STORM SEWER IMPROVEMENTS
to serve
Lots 54-66, St. Francis JR Mead Addition
FLATS 324 - 324 N. Emporia Ave.
CITY OF WICHITA, KANSAS
Gary Janzen, P.E., City Engineer
0336 PPD (607861)

APPROVED AS NOTED
BY WICHITA PUBLIC WORKS ENGINEERING
AND STORMWATER DIVISION

AS BUILTS

Flats-324 Addition
 Plan and Profile
 Wichita, Kansas

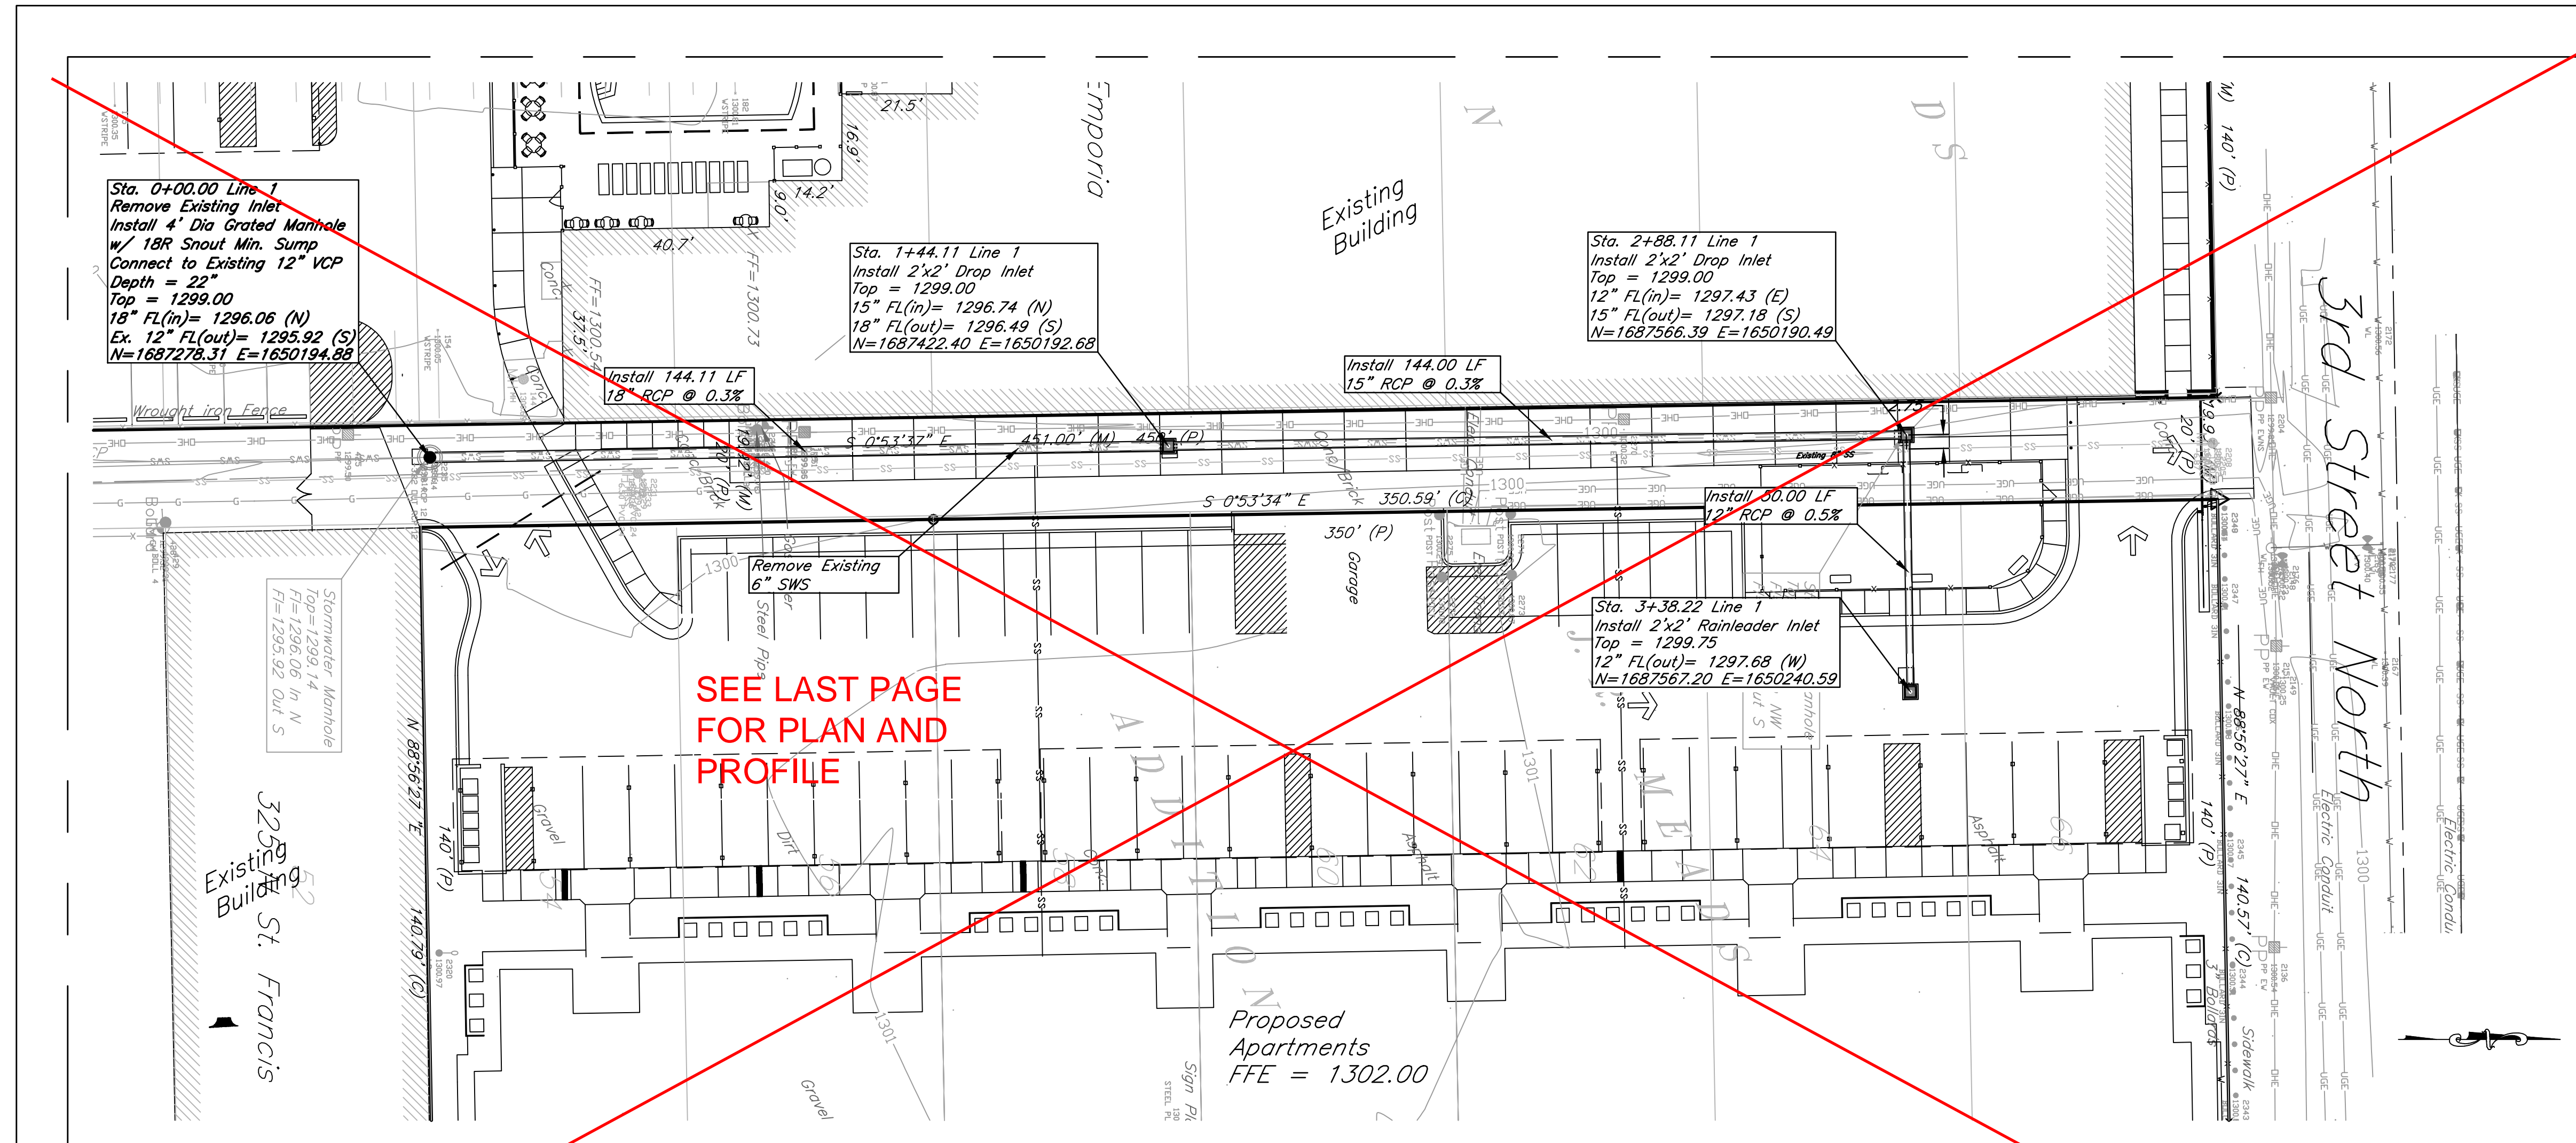
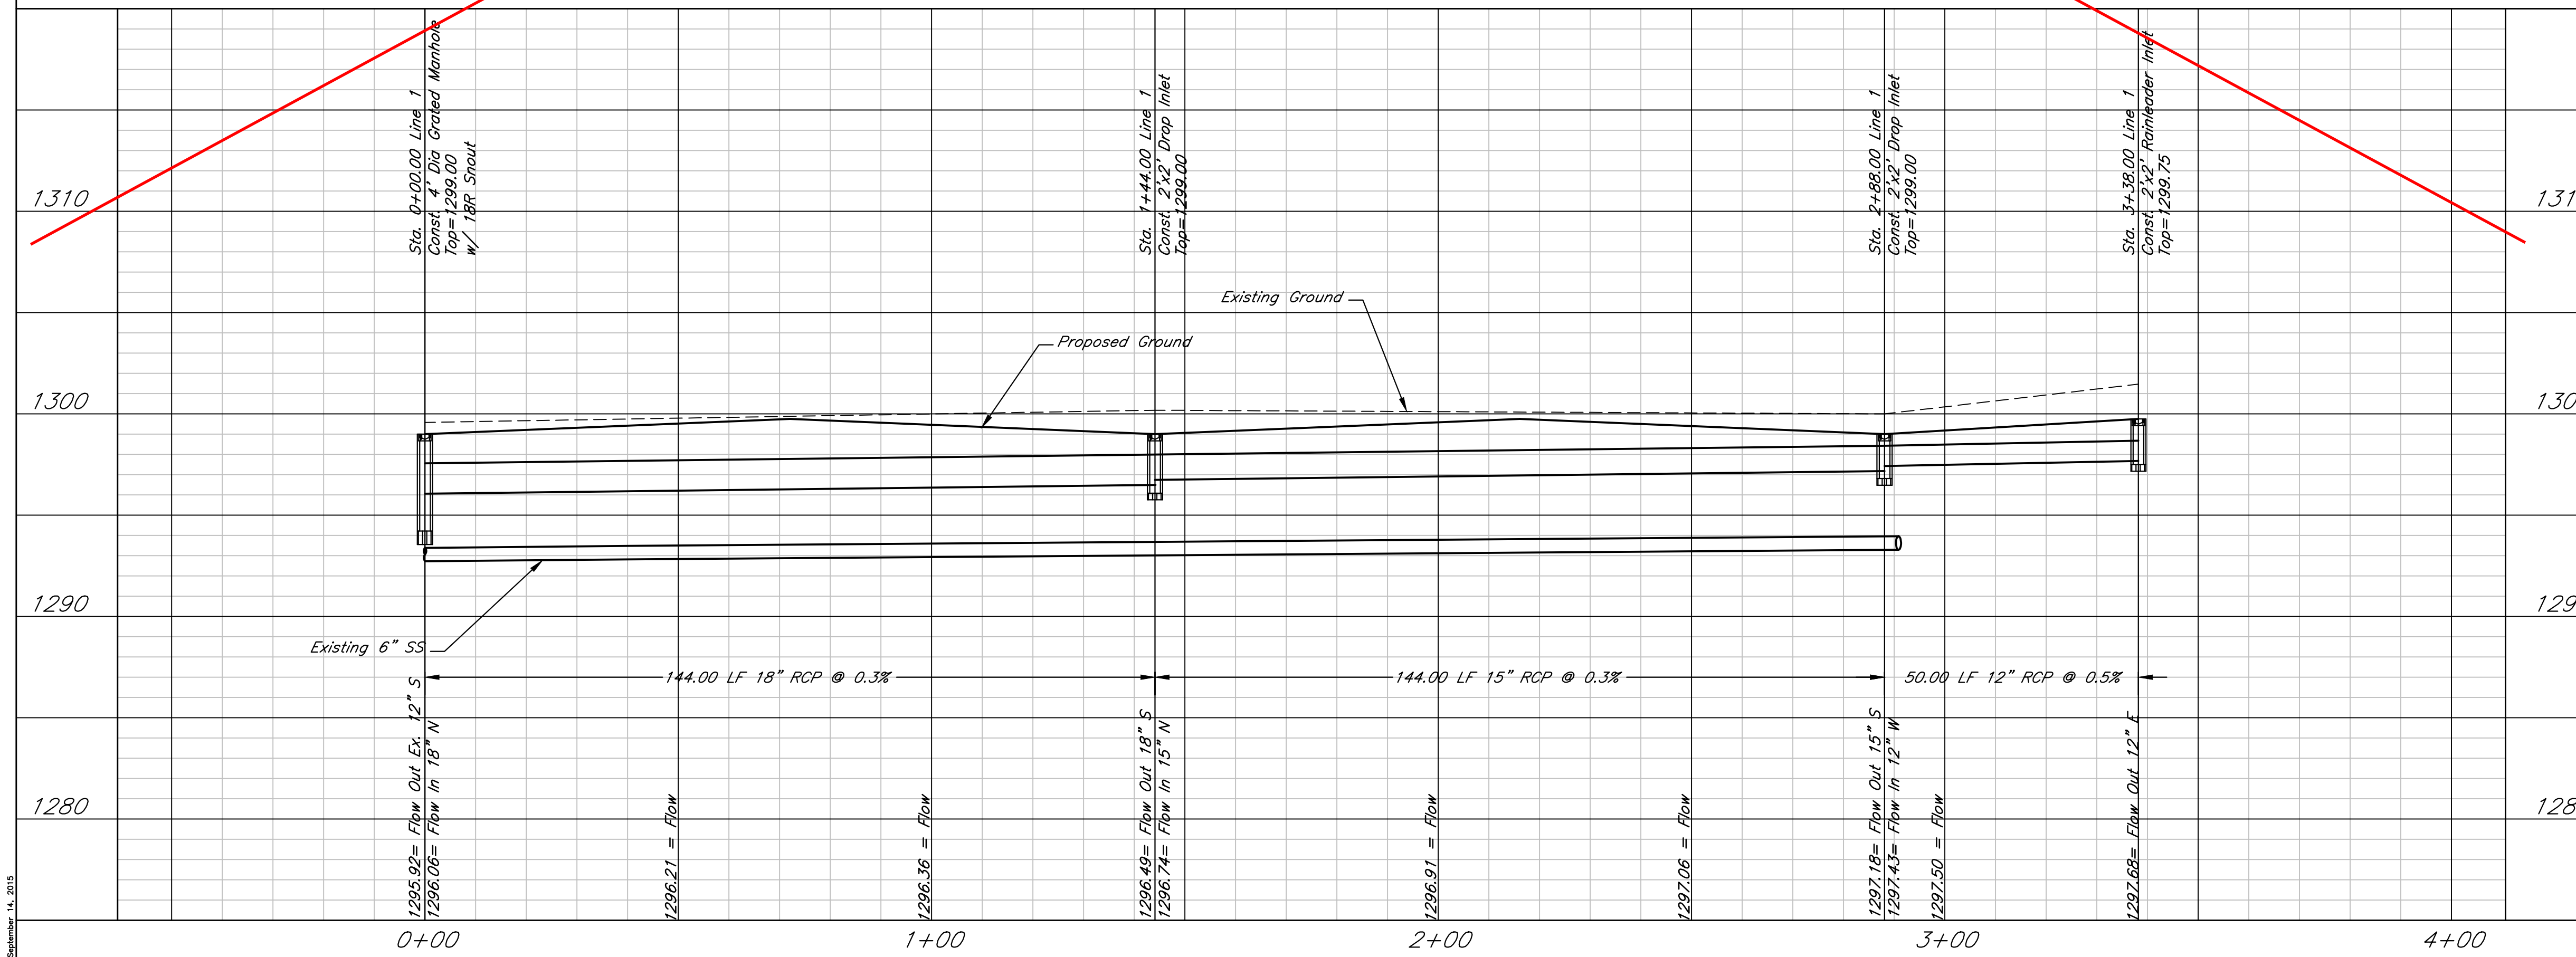
see new page 3

SEE LAST PAGE FOR PLAN AND PROFILE
